AMENDMENT OF SOLICITATION/MODIFICATION OF CONTRACT				1. CONTRACT ID CODE		PAGE OF PAGES 1 94	
2. AMENDMENT/MODIFICATION NO. 0005		3. EFFECTIVE DATE 28-Dec-2008		4. REQUISITION/PURCHASE REQ. NO.		5. PROJECT NO.(If applicable)

14. DESCRIPTION OF AMENDMENT/MODIFICATION (Organized by UCF section headings, including solicitation/contract subject matter where feasible.) ANA TRAINING RANGE COMPLEX, MEZAR-e-SHARIF, AFGHANISTAN THE PURPOSE OF THIS AMENDMENT TO SOLICITATION W917PM-09-R-0007 IS TO MAKE CHANGES ON SECTION 00010, SECTION 00110, SECTION 00120, SECTION 01010, SECTION 01015 AND INCORPORATE THE ANSWERS FROM THE CONTRACTOR'S QUESTIONS. THE TECHNICAL AND PRICE PROPOSAL REVISED DUE DATE OF 10 JANUARY 2009 IS HEREBY EXTENDED. THE NEW PROPOSAL DUE DATE IS 24 JANUARY 2009. ALL OTHER TERMS AND CONDITIONS REMAIN UNCHANGED.							
Except as provided herein, all terms and conditions of the document referenced in Item 9A or 10A, as heretofore changed, remains unchanged and in full force and effect.							
15A. NAME AND TITLE OF SIGNER (Type or print)				16A. NAME AND TITLE OF CONTRACTING OFFICER (Type or print)			
				TEL: _____ EMAIL: _____

List of all questions that are asked by Contract

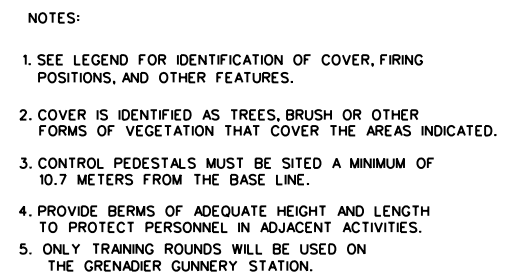
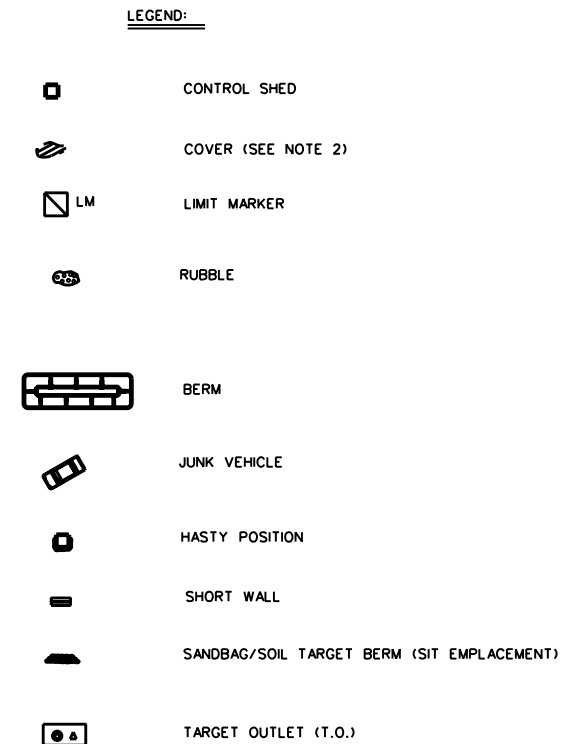
Note: Place dirt berm 75m behind, and perpendicular to, the 4 dirt berms that make up the course lanes.

BUILDING LAYOUT - PLAN VIEW

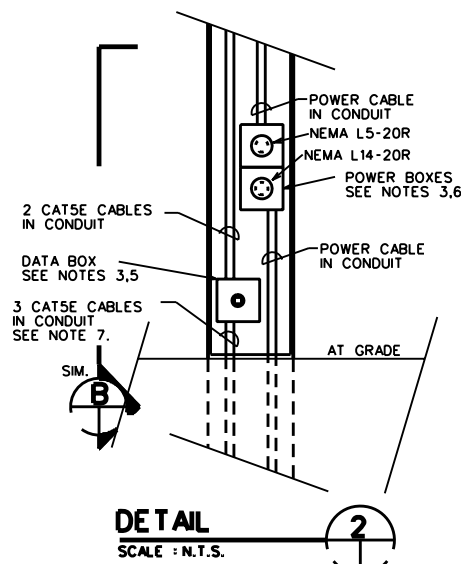
Note: The construction of these buildings(1,2,3,4,5,6 & 7) for Station 2 of Urban Combat Area shall be considered as an option.

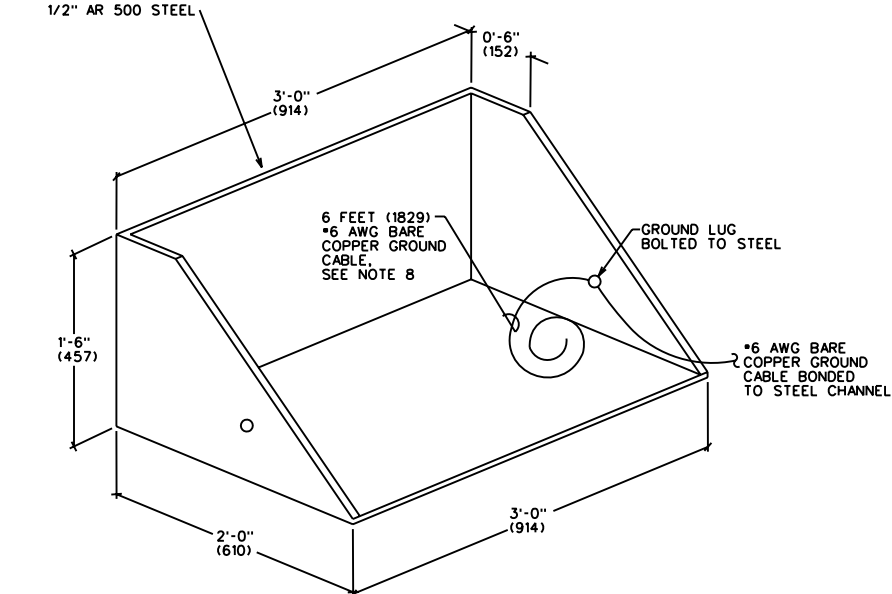
Note: The construction of these buildings(1,2,3,4,5,6 & 7) for Station 2 of Urban Combat Area shall be **BUILDING LAYOUT - PLAN VIEW** considered as an option.
